Request for Interpretation No. 95

AC Class Rule Version 1.11: June 8th 2017

Diagram 1

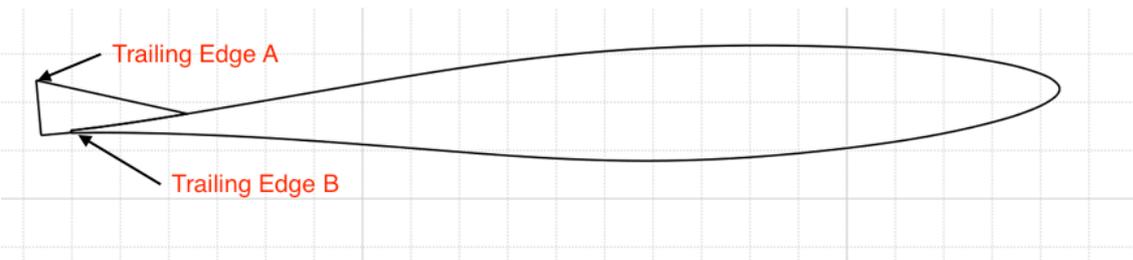
1. Is it permitted to attach a device to a **rudder wing** section whose primary purpose or effect is to circumvent the measured **rudder wing** chord angle limits of Rule 10.10 when the **rudder** is in **appendage measurement condition**? An example is shown in Diagram 1.

2. Would such a device be considered an additional **appendage** attached to a **rudder** or **rudder wing**, or would it be considered part of a **rudder wing**?

3. If a device as described above is permitted as part of a **rudder wing**, must its primary function be to affect pitch of the platform?
4. If the answer to question 3 above is "yes", what test will the **Measurement Committee** apply to determine compliance?

1. The **AC Class Rule** does not limit the geometry of the **rudder wings** other than as specified in Rules 10.2, 10.7, 10.8, 10.9, 10.10. and 10.11(c). There is not enough information in Diagram 1 to determine if the arrangement complies with all **AC Class Rules**, but it would be possible to design a **rudder wing** with the section shape shown and have it comply with the **AC Class Rule**.
2. The **rudder wing** component would be considered part of the **rudder wing** provided it complies with Rule 10.7.
3. No. Rule 1.4 (ee) defines a **rudder wing** as “an appendage attached to a rudder and primarily used to affect pitch”. Not every component of a **rudder wing** is mandated to affect pitch as its primary use.
4. Not applicable.
5. Within the limits set out in Rule 10, local modifications to the **rudder wing** geometry to achieve **AC Class Rule** compliance are not prohibited.

Diagram 2

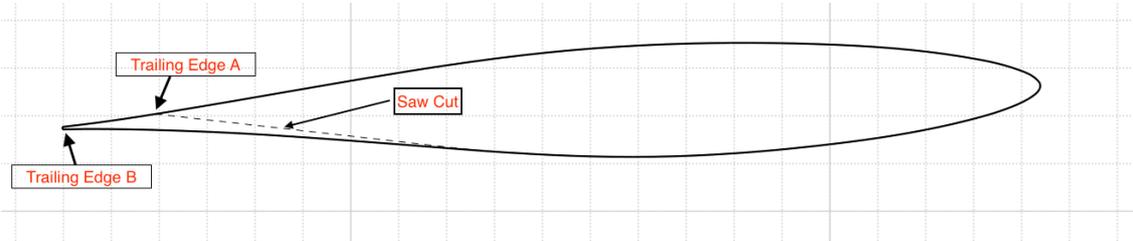
5. Is it permitted to locally modify the **rudder wing** at the 80 mm section, the purpose or effect would be to circumvent the measured **rudder wing** chord angle limits of Rule 10.10 when the **rudder** is in **appendage measurement condition**? An example is shown in Diagram 2 where a "saw cut" (dotted line) modifies the local trailing edge and therefore the local chord.
